From: Schultz, Josie M - DNR
Sent: Tuesday, March 1, 2022 11:19 AM
To: Yahoo Mail; Tim.Welch@terracon.com
Subject: RE: DHS planning passive sampling at Jim's Music - One Hour Martinizing, BRRTS # 02-05-217270

I will be picking up the samples today to send to the state lab of hygiene; six passive samplers were deployed at Jim's Music. Curtis Hedman mentioned the state lab is pretty busy right now, so it will likely take a couple weeks or more to receive results but I will most certainly forward results to you and Dr. Neziri once I receive them.

Open hole in the
at the base of the
northern basement

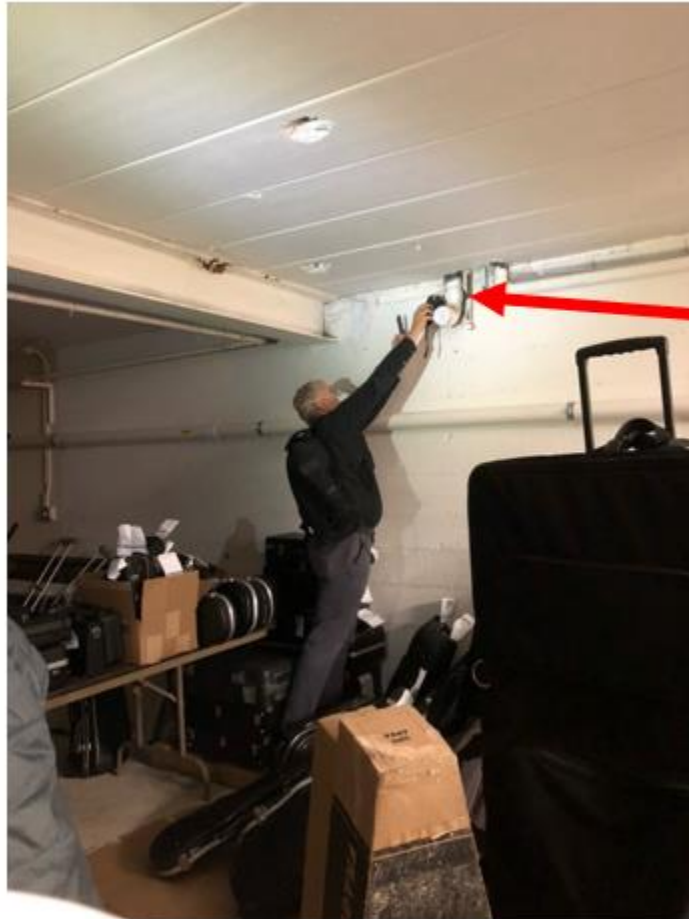
- Also noted was that the sump/ejector pit at the base of the stairs in the northern basement has an approximately 4" hole open in the cover that may also be a source for vapors. This sump had headspace sampled in the past and had detections of PCE above VRSLs, so is likely contributing to indoor air in the basement.
